Product Change Notification

PCN#: 257

Change Title: HC49SDLF Series Dimensional Changes

HC49SDLF Dimensional Changes 11/20/06

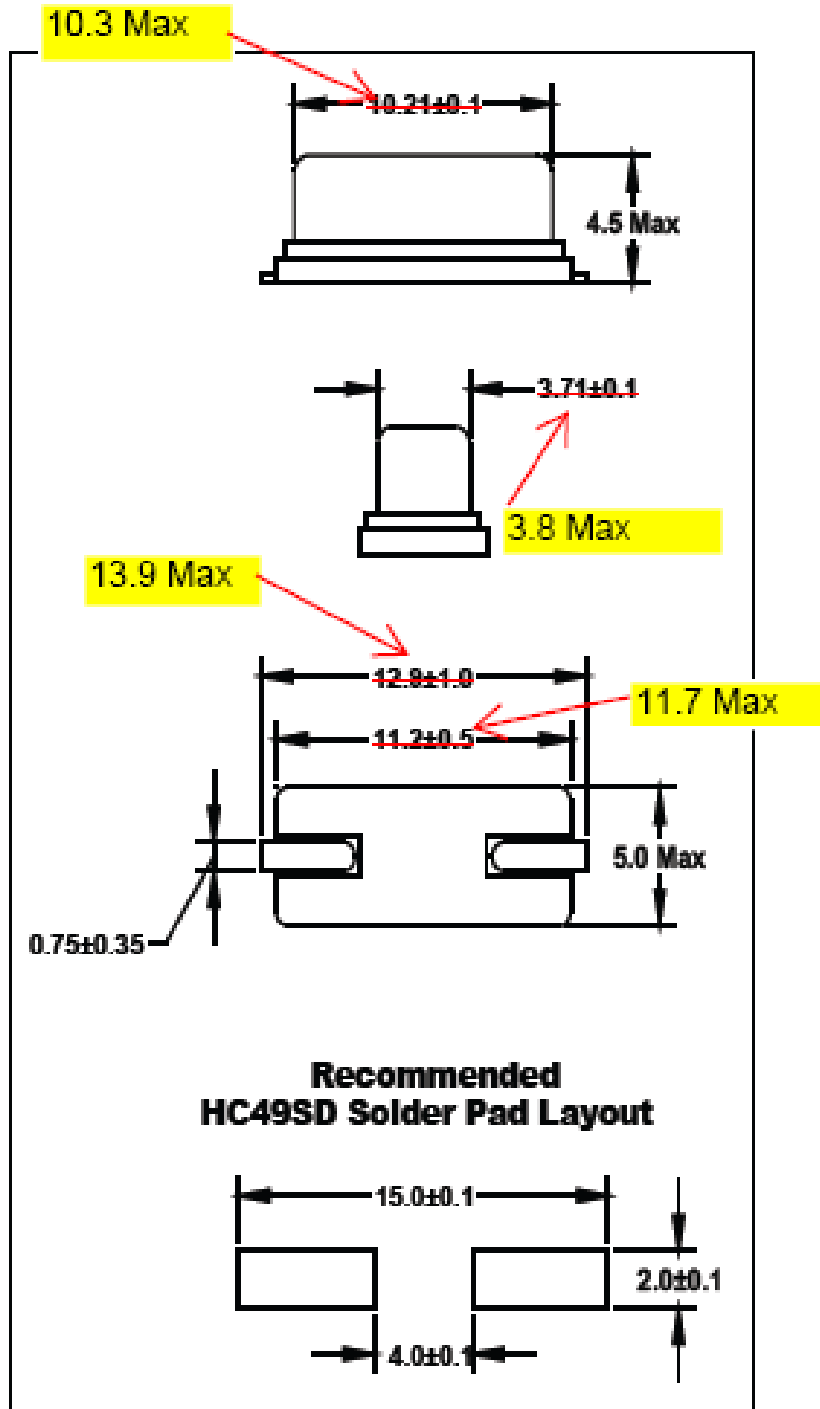
Top of can length – from 10.21 ± 0.1 mm to 10.3mm Max
Top of can width – from 3.71 ± 0.1 mm to 3.8mm Max
Base insulator length – from 11.2 ± 0.5 mm to 11.7mm Max
Total length – from 12.9 ± 1.0 mm to 13.9mm Max

A markup showing the exact changes and a revised dimensional drawing are attached.
